2. SAFETY LIMITS AND LIMITING SAFETY SYSTEM SETTINGS

MARKUP OF CURRENT ANO-1 TECHNICAL SPECIFICATIONS

(FOR INFO ONLY)

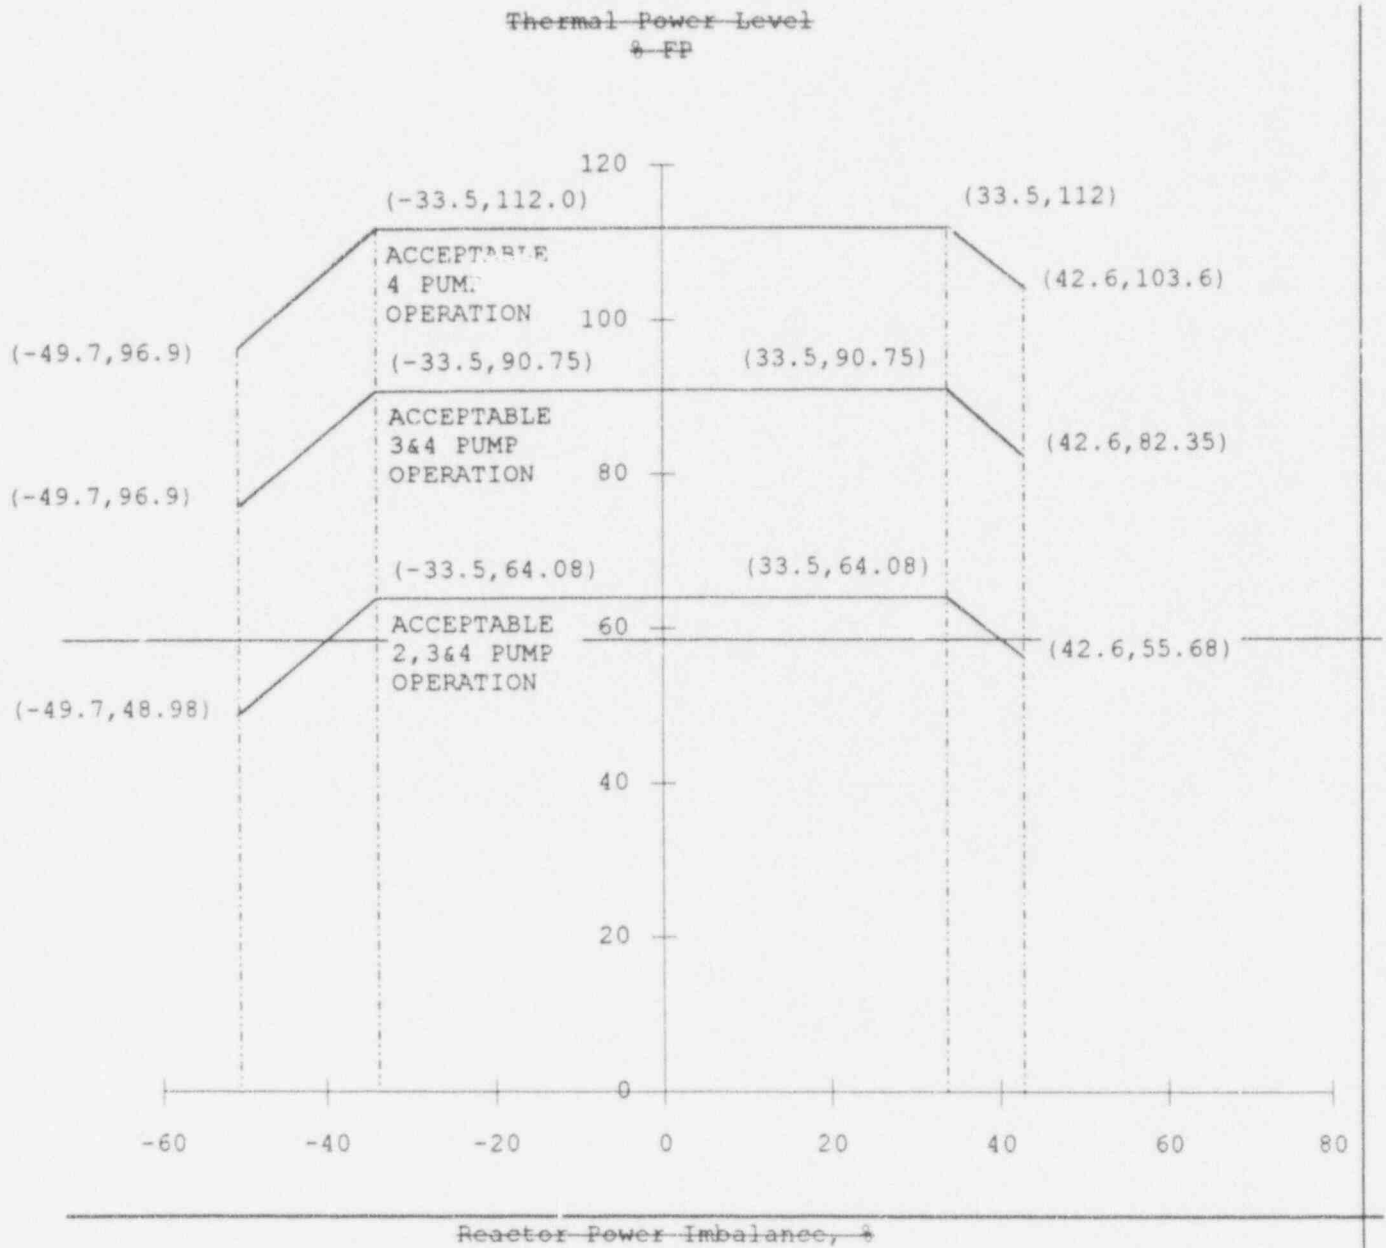
2.1.1 The maximum local fuel pin centerline temperature shall be $\leq 5080 - (6.5 \times 10^{-3} \times (\text{Burnup, MWD/MTU})^\circ\text{F})$ for TACO2 applications and $\leq 4642 - (5.8 \times 10^{-3} \times (\text{Burnup, MWD/MTU})^\circ\text{F})$ for TACO3 applications. Operation within this limit is ensured by compliance with the Axial Power Imbalance protective limits preserved by Table 2.3-1 "Reactor Protection System Trip Setting Limits," as specified in the COLR. The combination of the reactor system pressure and coolant temperature shall not exceed the safety limit as defined by the locus of points established in Figure 2.1-1. If the actual pressure/temperature point is below and to the right of the pressure/temperature line the safety limit is exceeded.

2.1.2 The departure from nucleate boiling ratio shall be maintained greater than the limits of 1.3 for the BAW-2 correlation and 1.18 for the BWC correlation. Operation within this limit is ensured by compliance with Specification 2.1.3 and with the Axial Power Imbalance protective limits preserved by Table 2.3-1 "Reactor Protection System Trip Setting Limits," as specified in the COLR. The combination of reactor thermal power and reactor power imbalance (power in the top half of the core minus the power in the bottom half of the core expressed as a percentage of the rated power) shall not exceed the safety limit as defined by the locus of points for the specified flow set forth in Figure 2.1-2. If the actual reactor thermal power/reactor power imbalance point is above the line for the specified flow, the safety limit is exceeded.

The Axial Power Imbalance Protective Limits in the COLR curves of Figure 2.1-2 are based on the more restrictive of two thermal limits and include the effects of potential fuel densification:

- 2.1.1 The maximum local fuel pin centerline temperature shall be $\leq 5080 - (6.5 \times 10^{-3} \times (\text{Burnup, MWD/MTU})^\circ\text{F})$ for TACO2 applications and $\leq 4642 - (5.8 \times 10^{-3} \times (\text{Burnup, MWD/MTU})^\circ\text{F})$ for TACO3 applications. Operation within this limit is ensured by compliance with the Axial Power Imbalance protective limits preserved by Table 2.3-1 "Reactor Protection System Trip Setting Limits," as specified in the COLR.

- 2.1.2 The departure from nucleate boiling ratio shall be maintained greater than the limits of 1.3 for the BAW-2 correlation and 1.18 for the BWC correlation. Operation within this limit is ensured by compliance with Specification 2.1.3 and with the Axial Power Imbalance protective limits preserved by Table 2.3-1 "Reactor Protection System Trip Setting Limits," as specified in the COLR.

The Axial Power Imbalance Protective Limits in the COLR are based on the more restrictive of two thermal limits and include the effects of potential fuel densification:

Protective System Maximum Allowable Setpoints
 ANO-1, Figure 2.3-2

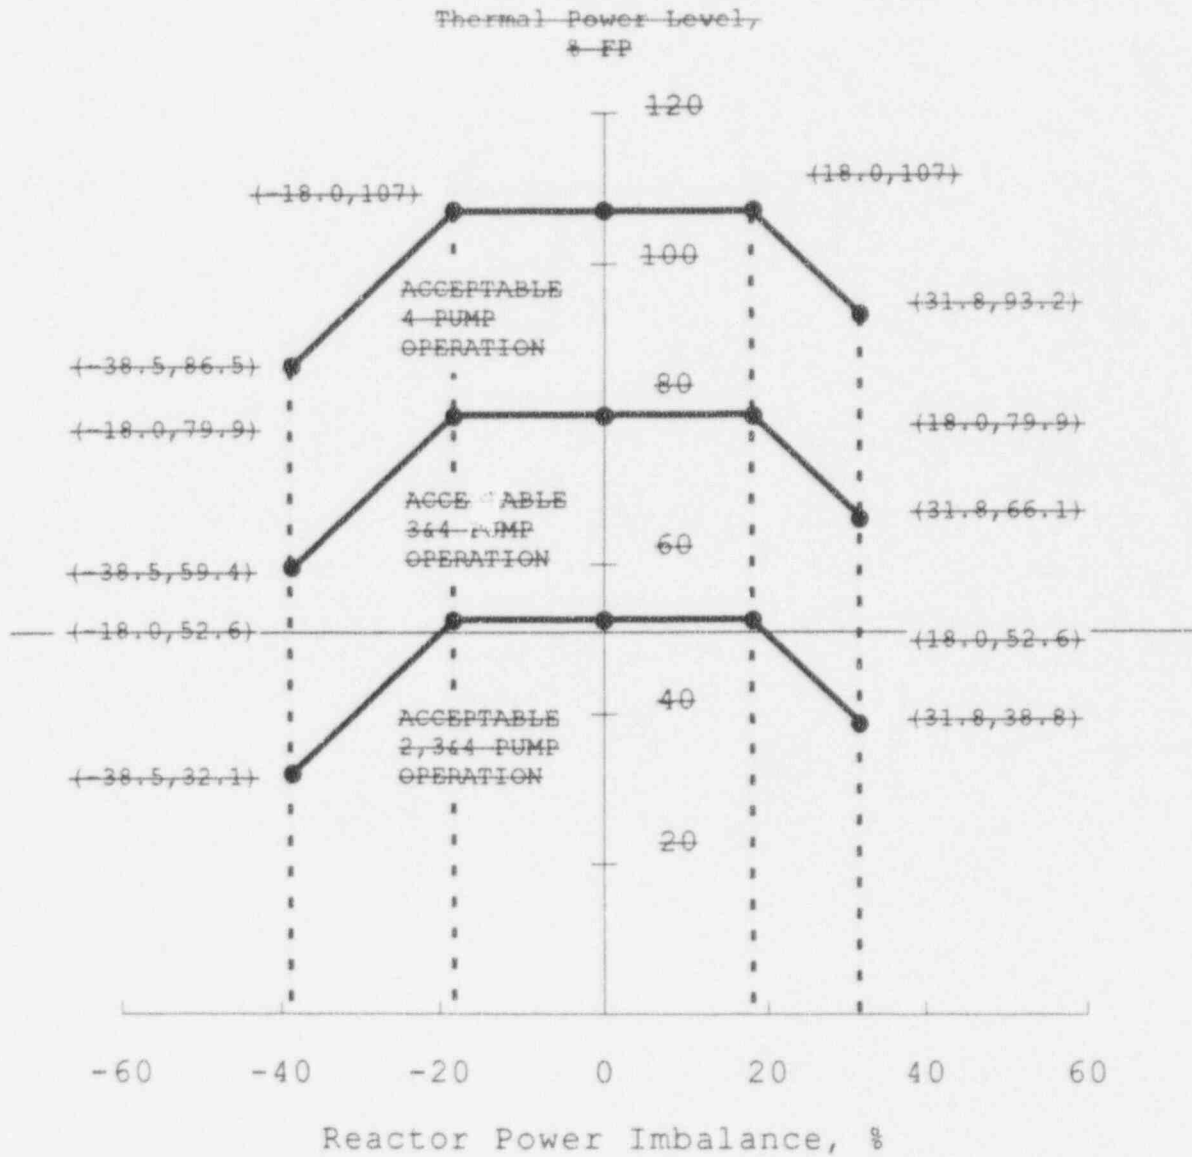
- 2.3.1 The reactor protection system trip setting limits and the permissible bypasses for the instrument channels shall be as stated in Table 2.3-1 and the Protection System Maximum Allowable Setpoints for Axial Power Imbalance as given in the COLR Figure 2.3-2.

- a. The ~~Protection System~~ Maximum Allowable Setpoints for Axial Power Imbalance in the COLR ~~(Figure 2.3-2)~~ shall be reduced 2% in power for each 1% tilt in excess of the tilt limit.

- 2.3.1 The reactor protection system trip setting limits and the permissible bypasses for the instrument channels shall be as stated in Table 2.3-1 and the Protection System Maximum Allowable Setpoints for Axial Power Imbalance as given in the COLR.

- a. The Protection System Maximum Allowable Setpoints for Axial Power Imbalance in the COLR shall be reduced 2% in power for each 1% tilt in excess of the tilt limit.
